**CAROLINA CROSSROADS
CONCEPTUAL SIGNING ALONG
PHASE 3C**

SHEET LAYOUT I-20

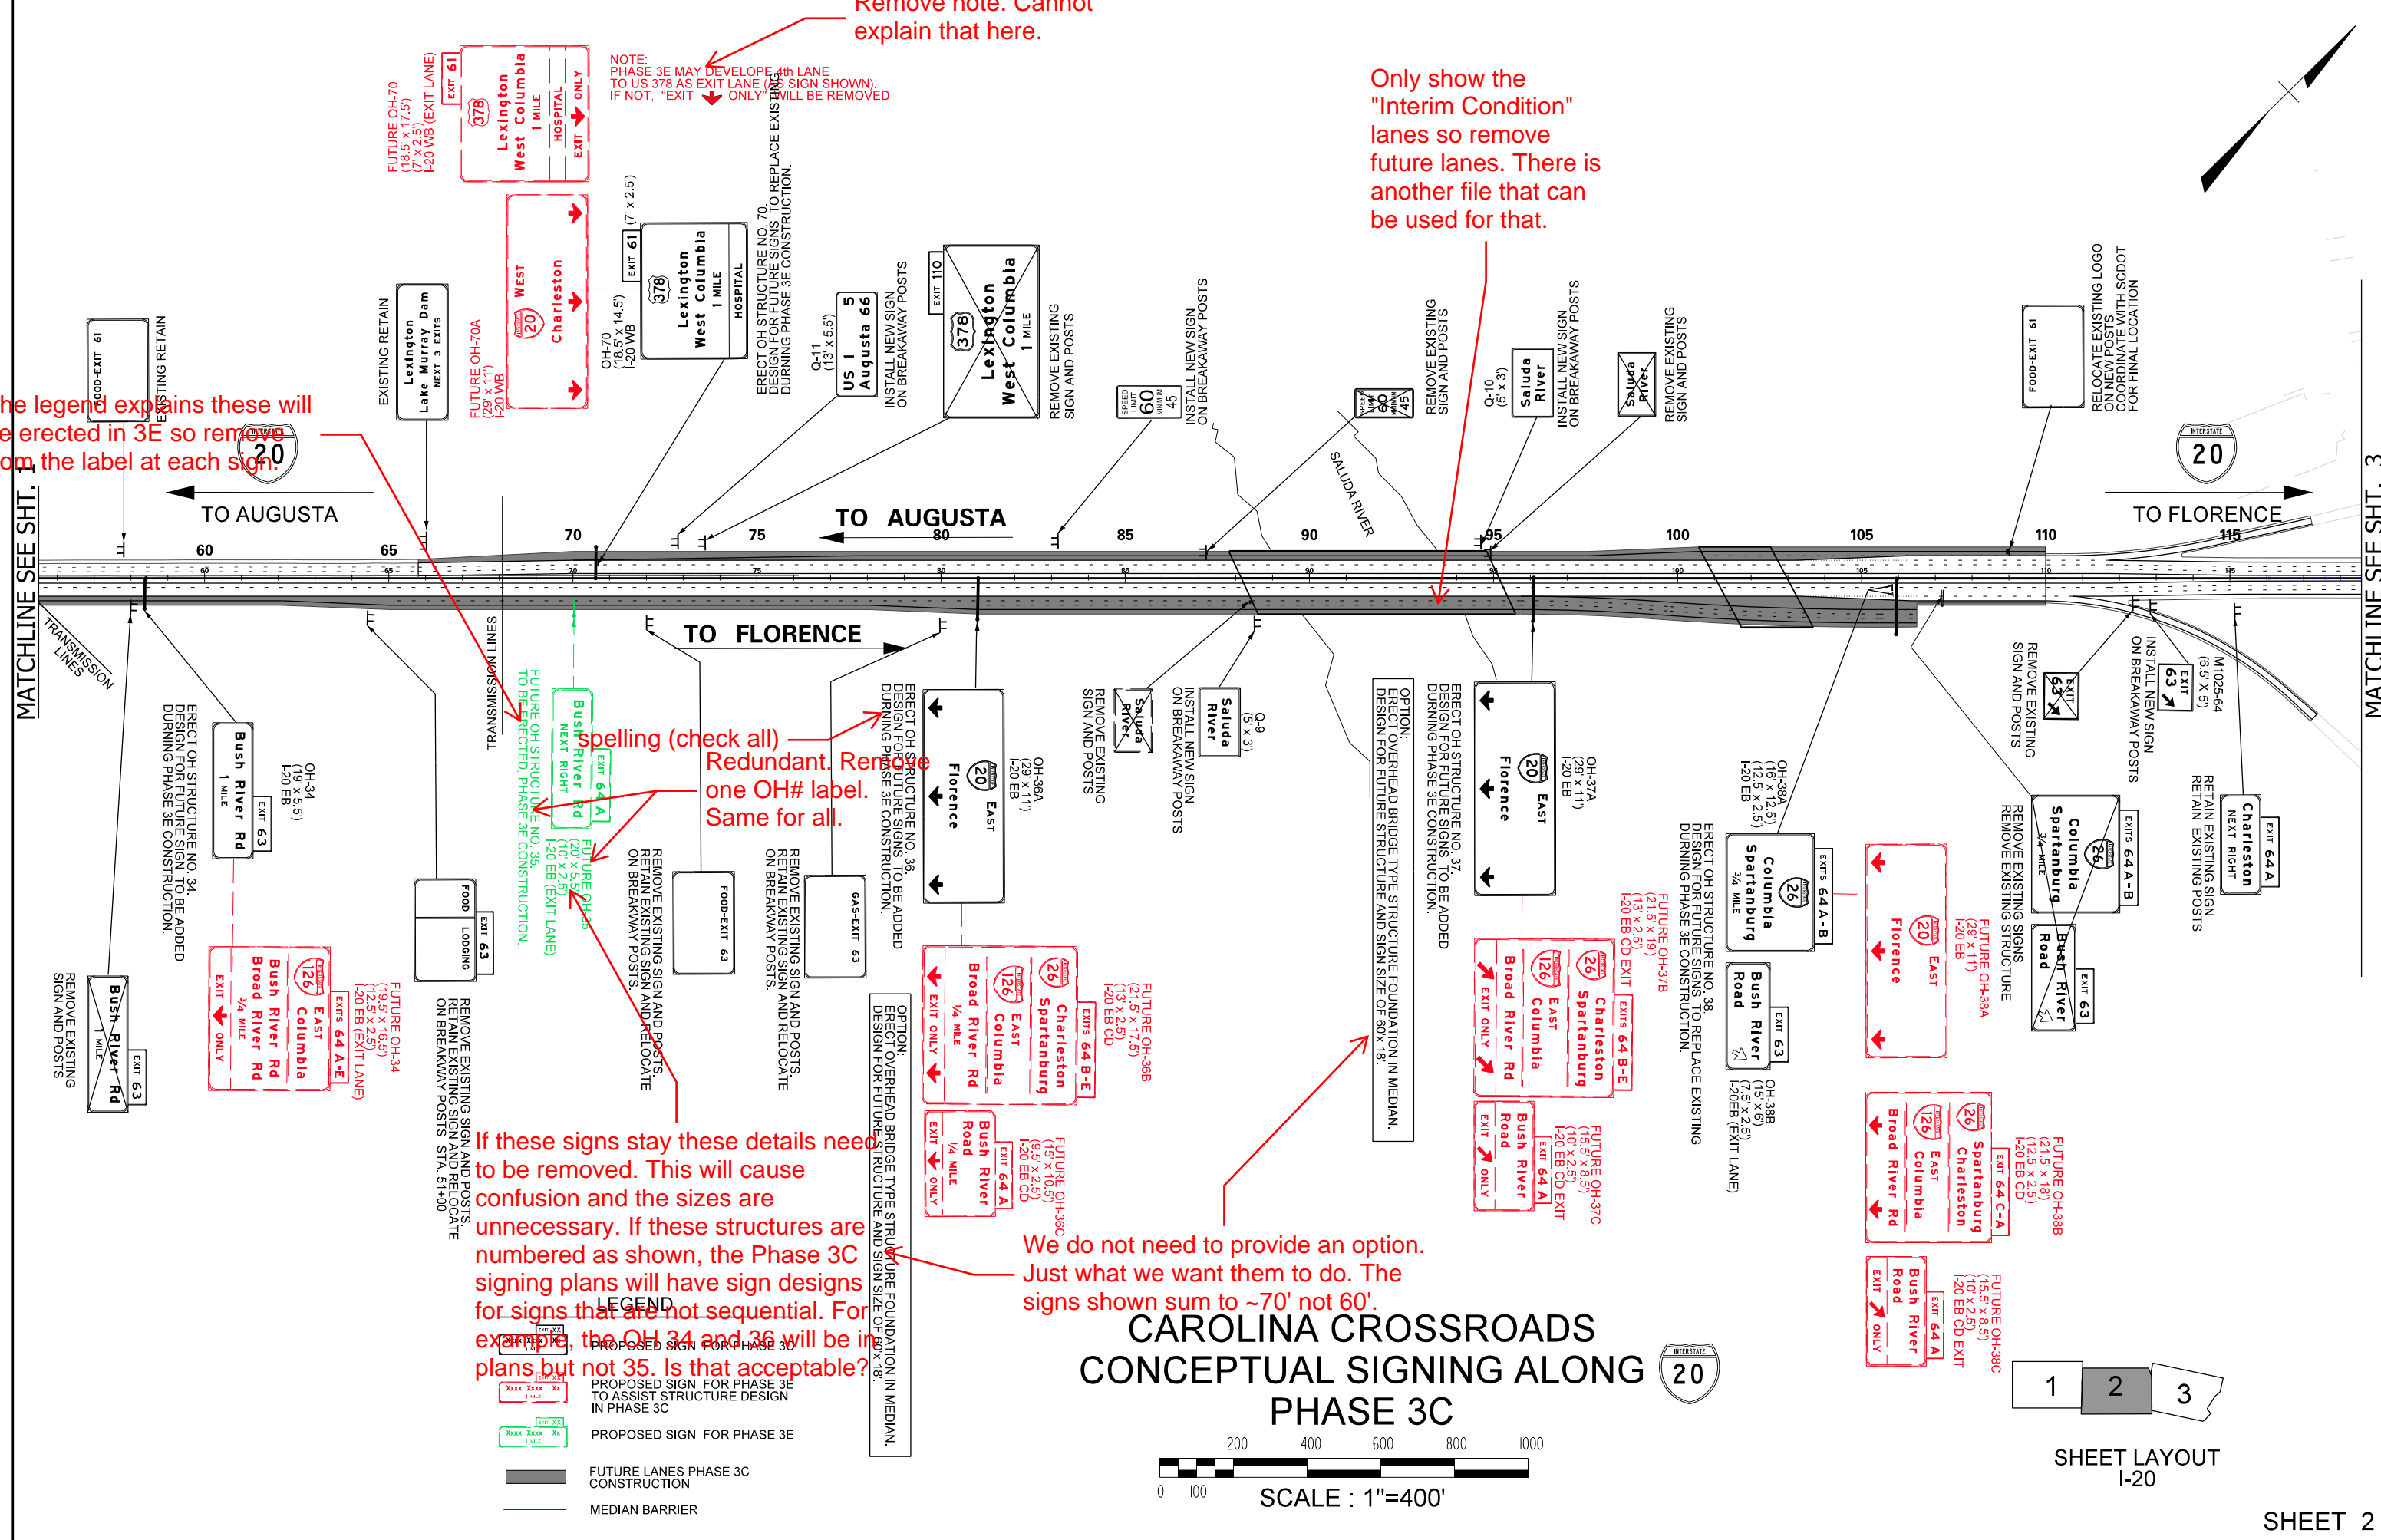
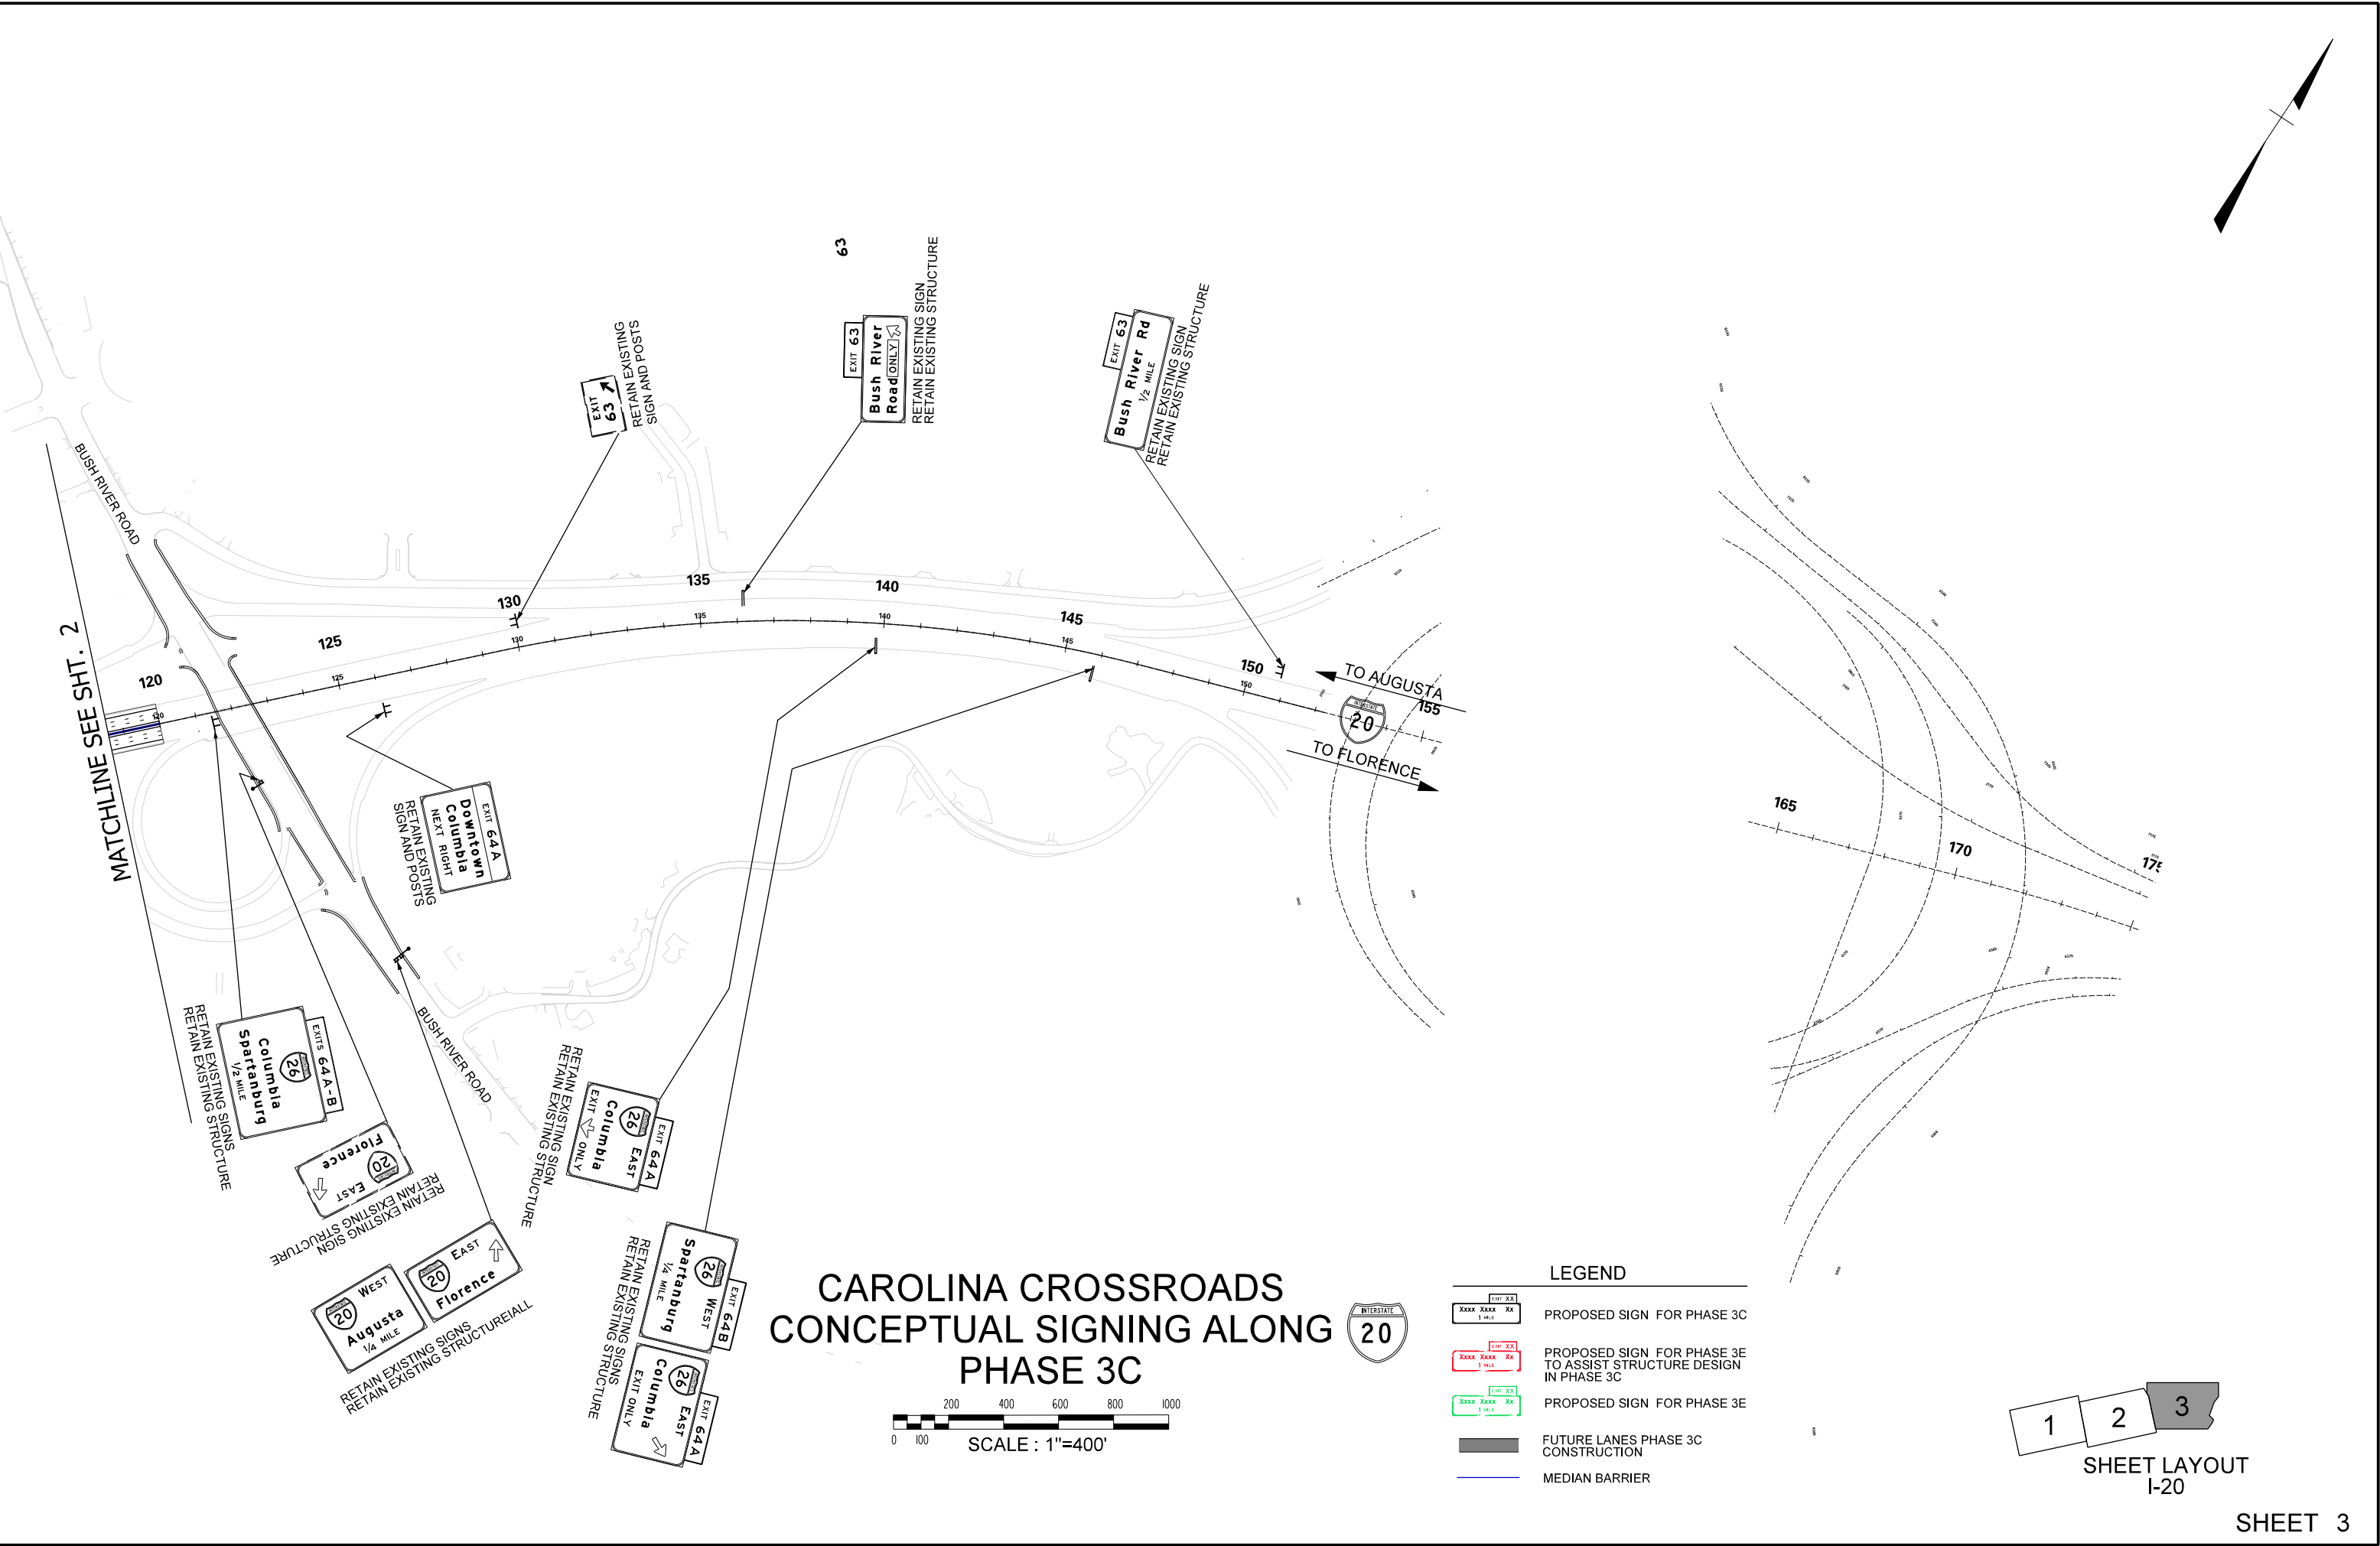
The legend explains these will be erected in 3E so remove from the label at each sign.

Remove note. Cannot explain that here.

Only show the "Interim Condition" lanes so remove future lanes. There is another file that can be used for that.

Spelling (check all) Redundant. Remove one OH# label. Same for all.

If these signs stay these details need to be removed. This will cause confusion and the sizes are unnecessary. If these structures are numbered as shown, the Phase 3C signing plans will have sign designs for signs that are not sequential. For example, the OH 34 and 36 will be in plans but not 35. Is that acceptable?

We do not need to provide an option. Just what we want them to do. The signs shown sum to ~70' not 60'.
